INTERIOR DEPARTMENT COMMENT ON NREL PHASE 1 REPORT

Comments on National Renewable Energy Laboratory Technical Report Navajo Generating Station and Air Visibility Regulations: Alternatives and Impacts

RE: Comments on NREL Report, *Navajo Generating Station and Air Visibility Regulations: Alternatives and Impacts*

Comments to the NREL report, *Navajo Generating Station and Air Visibility Regulations: Alternatives and Impacts* (the “Report”)

Annual Residential Water Costs

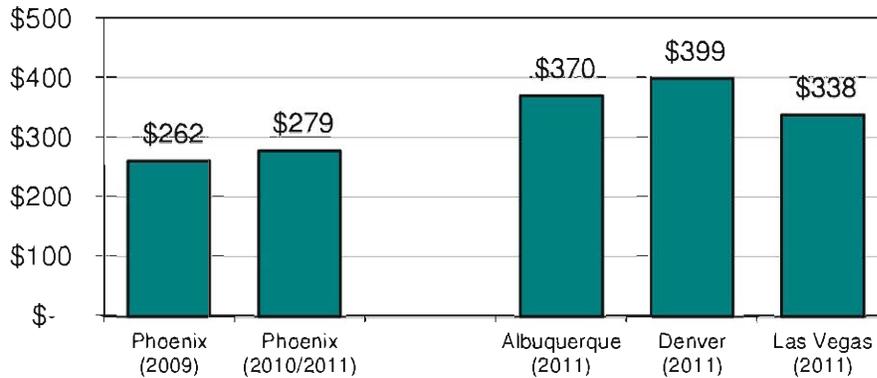
This rate impact is comparable to or less than rate increases the Phoenix water utility has imposed in recent years. For example, from 2009 to 2010, a typical household saw its annual water bill rise by over \$17. Even with these rate increases, Phoenix households pay less for water than residents in many other cities in the region (Figure 1).

Figure 1. Residential water costs in Phoenix in 2009 and 2010/2011 were lower costs in several other southwestern cities. (All costs reflect household use of 0.37 AF of water.)
